Re: Supplement IV in Response to Data Requests and Workshop Queries in Support of the Application for Certification for the Walnut Creek Energy Park (05-AFC-02)

Contents	1
Introduction	3
Transmission System Engineering	5
WSQ8 Generation Tie-Line Route.....	5
Visible Plume Modeling	11
DR77 Visible Plume Modeling Results.....	13
Visual Resources	17
DR91 Landscape and Irrigation Plan.....	19

WALNUT CREEK ENERGY PARK
CITY OF INDUSTRY, CALIFORNIA

SHEET TITLE: PLANTING PLAN
 PROJECT NAME: EDISON MISSION ENERGY
 DRAWN BY: BPK
 DATE: 7/21/06
 JOB NO.: CH2MHILL
 SHEET NO.: L-3
 OF 6 SHEETS

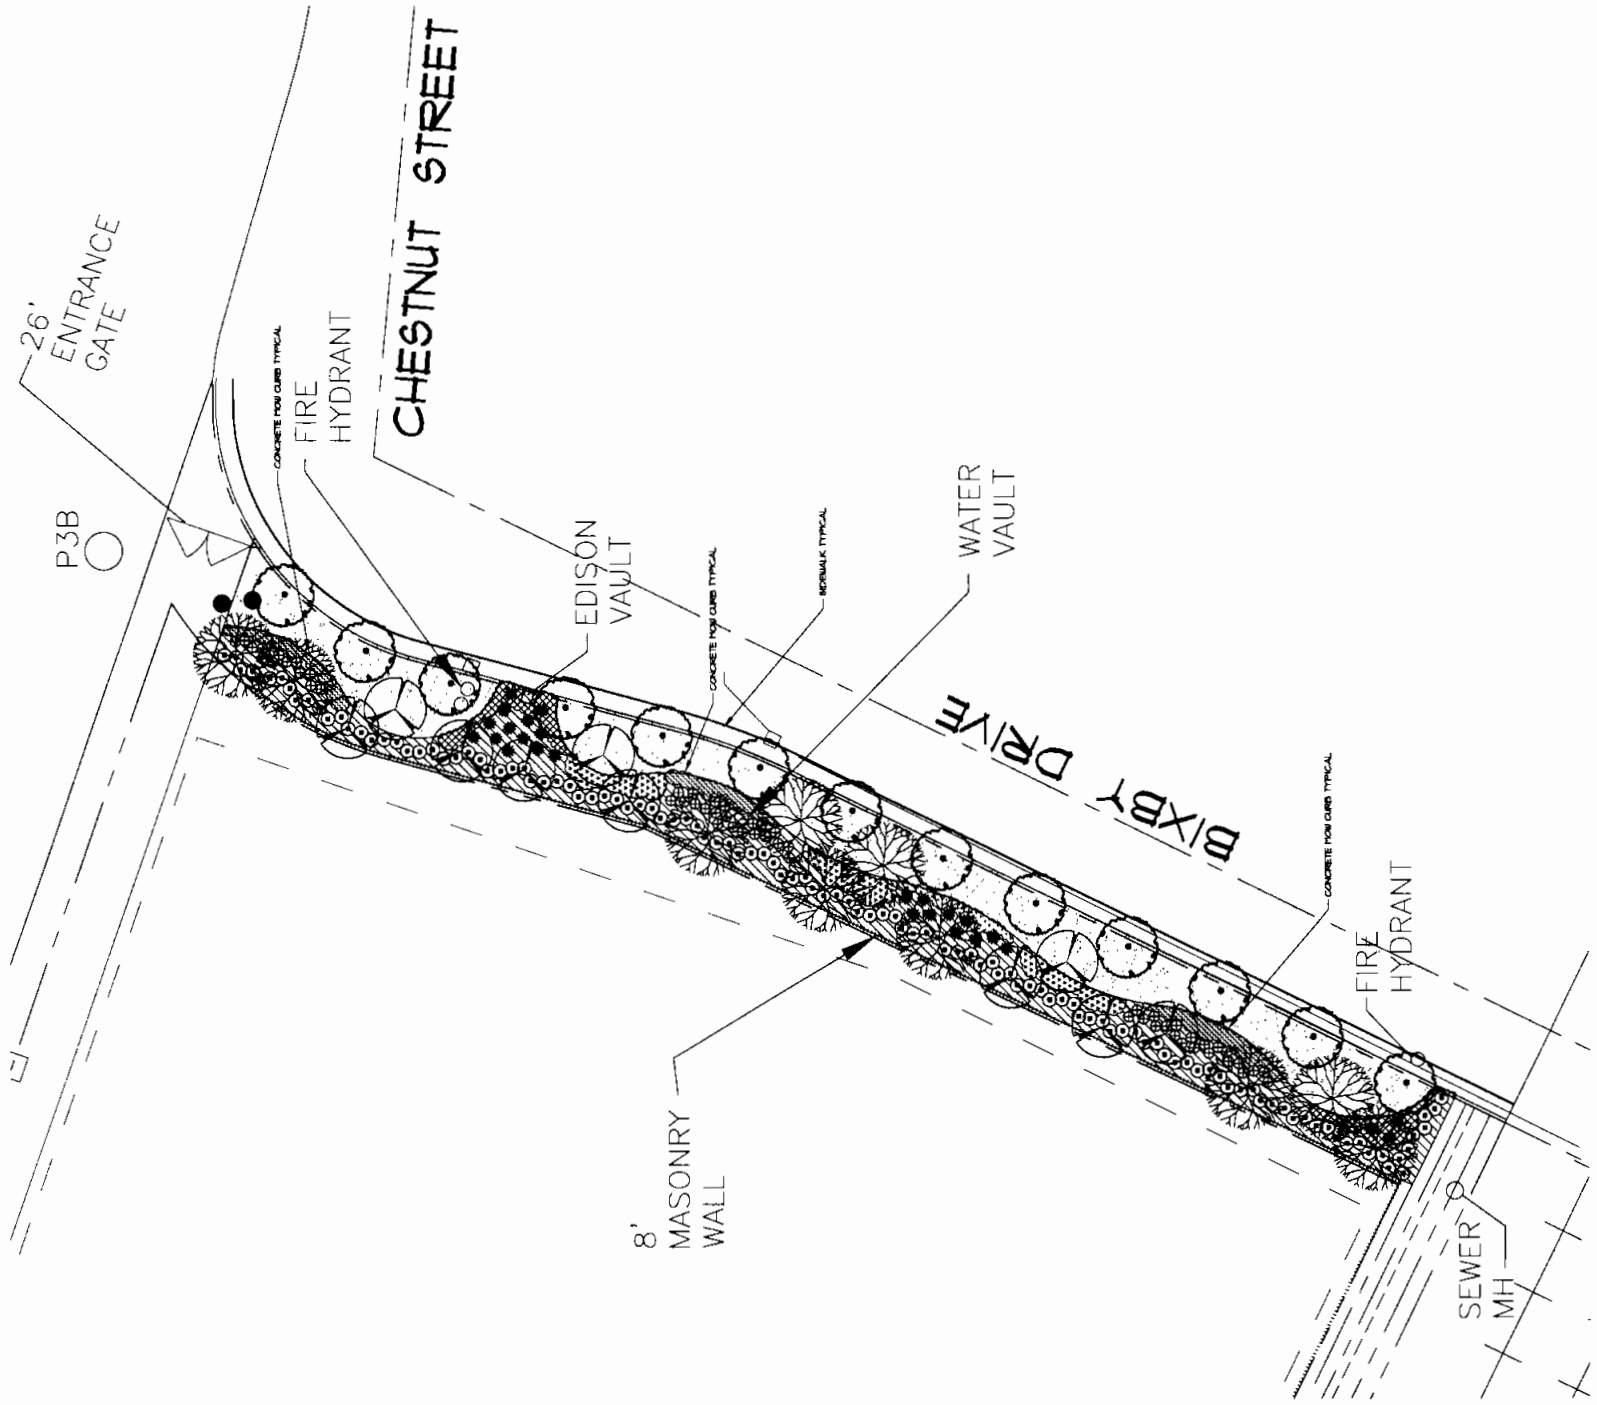
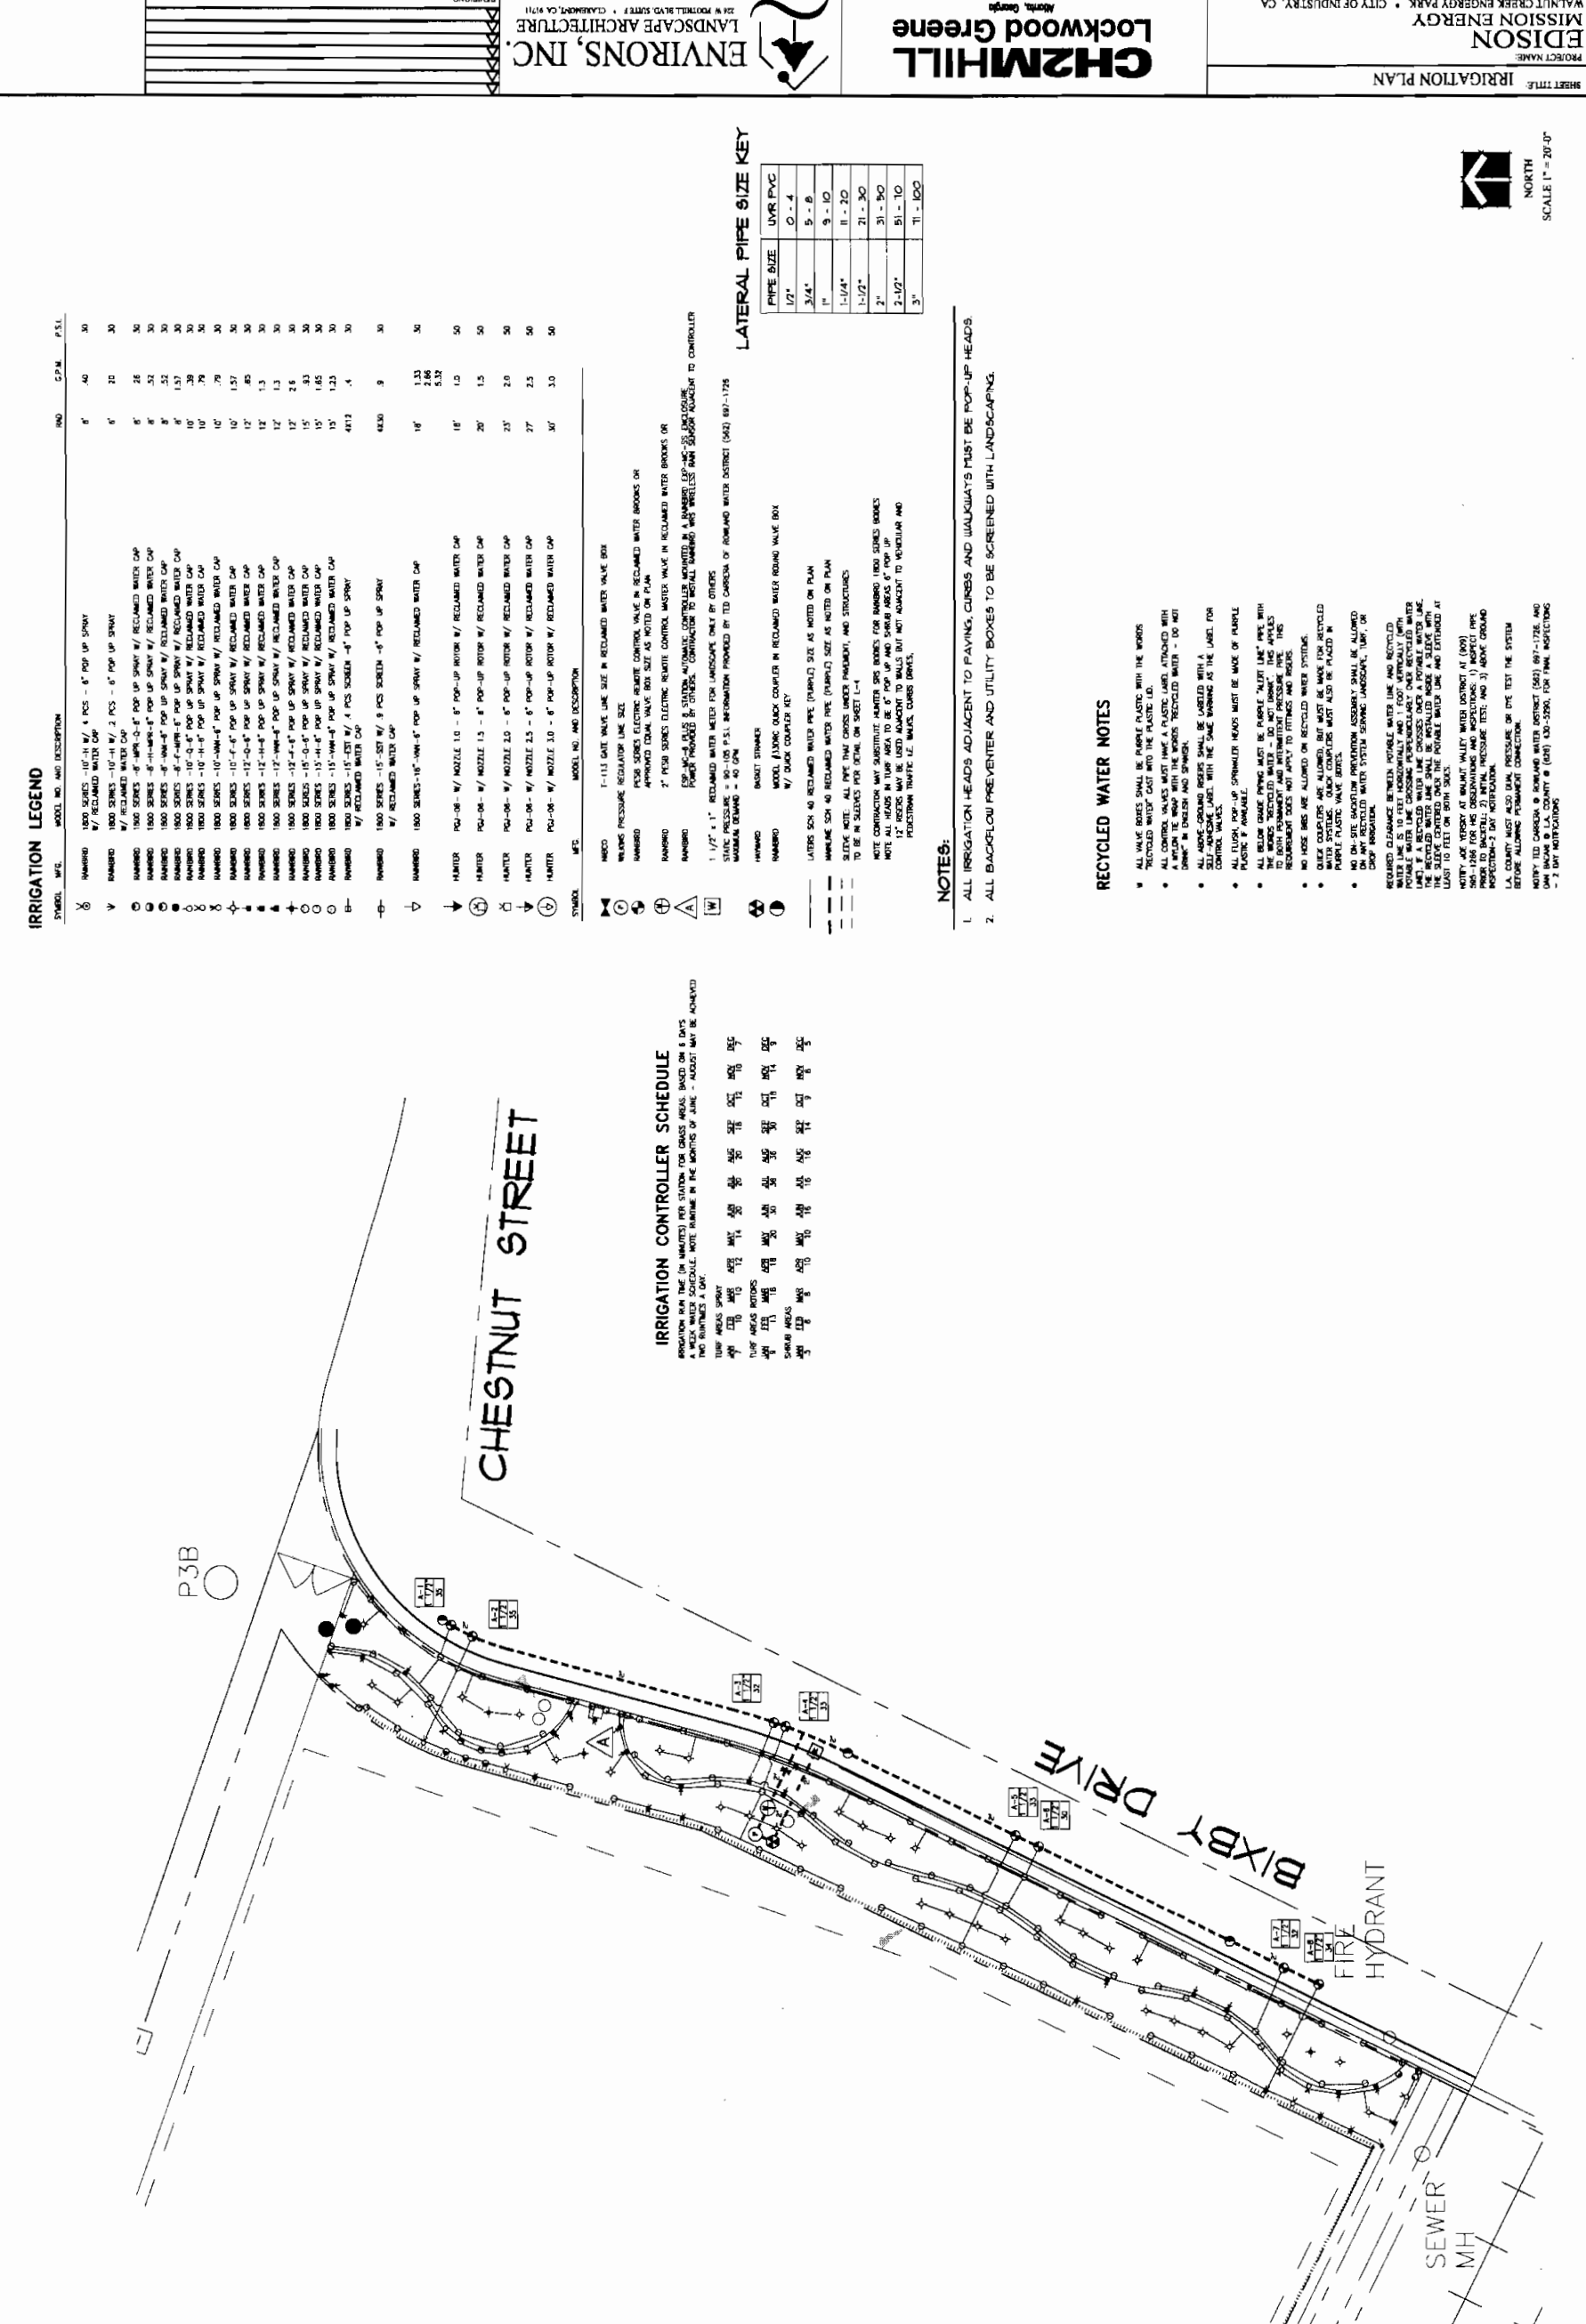
DR91. Please provide a landscape and irrigation plan that contains all the components required by the City.

Response: The landscape and irrigation plans are included as Attachment VIS-1.
